AMENDMENT 1 AMENDEMENT 1

**Residual current operated circuit-breakers with integral overcurrent protection
for household and similar uses (RCBOs) –
Part 1: General rules**

This amendment has been prepared by subcommittee 23E: Circuit-breakers and similar equipment for household use, of IEC technical committee 23: Electrical accessories.

Figure 7 – Typical diagram for all short-circuit tests except for 9.12.11.2.2

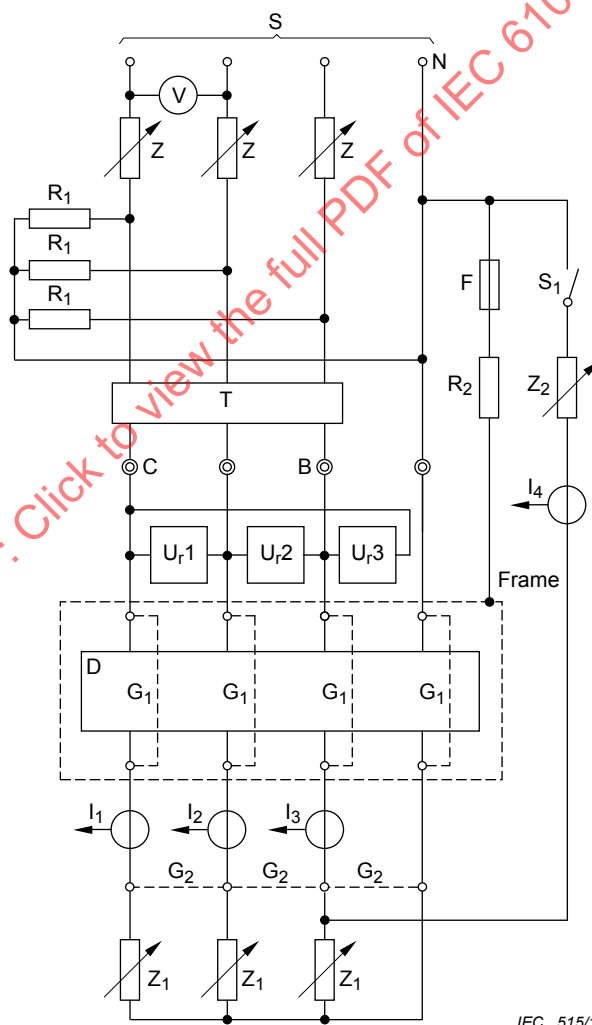
Replace Figure 7 by the following:

Figure 8 – Typical diagram for short-circuit tests according to 9.12.11.2.2

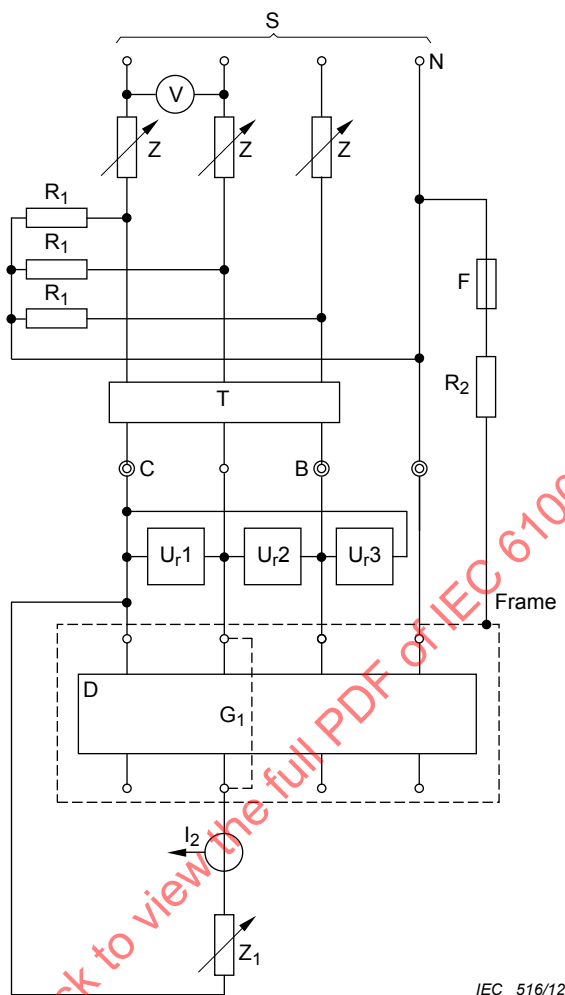
Replace Figure 8 by the following:

Figure 7 – Schéma type pour tous les essais de court-circuit à l'exception de celui du 9.12.11.2.2

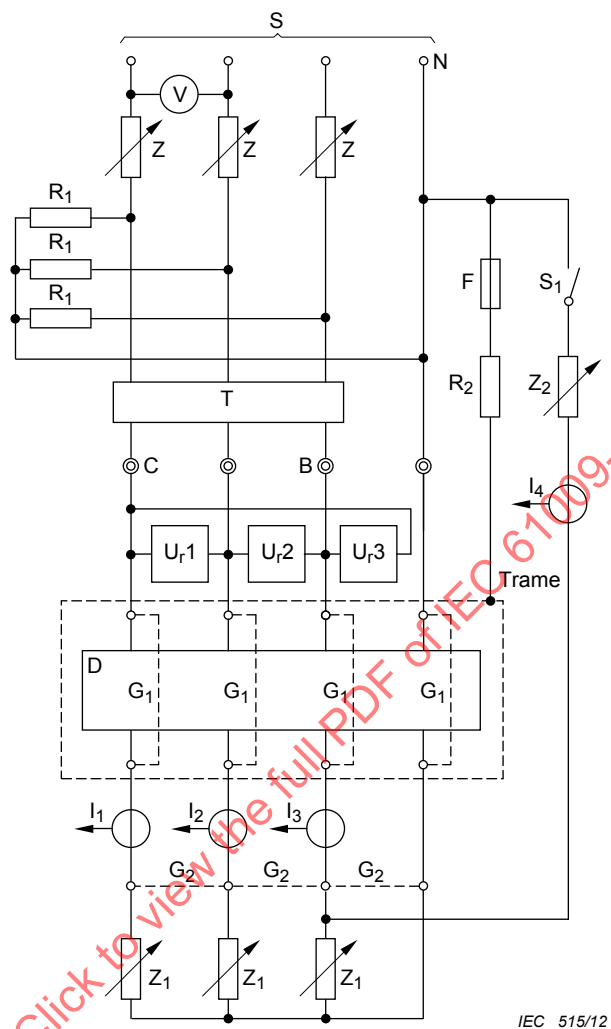
Remplacer la Figure 7 par ce qui suit:

Figure 8 – Schéma type pour les essais de court-circuit selon 9.12.11.2.2

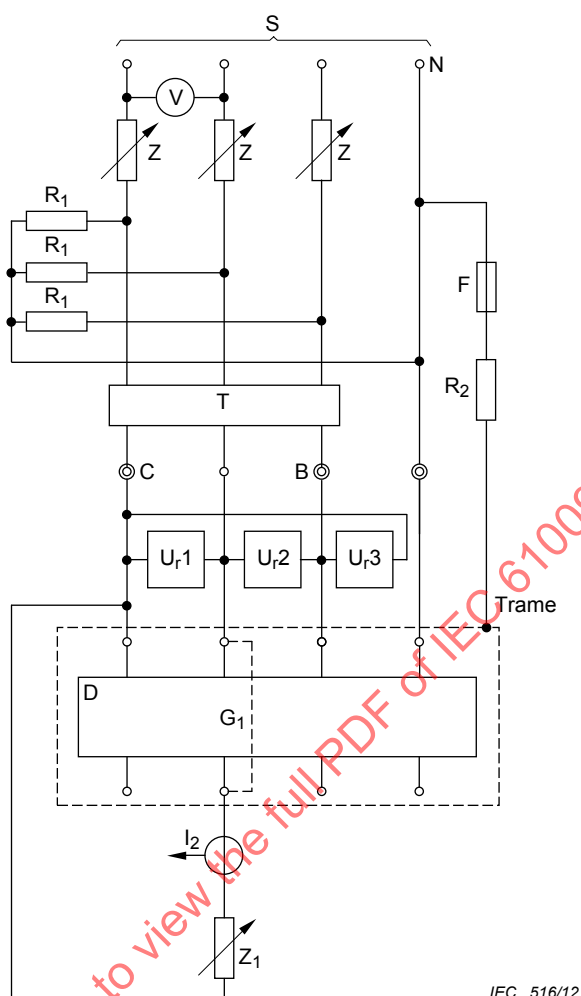
Remplacer la Figure 8 par ce qui suit:
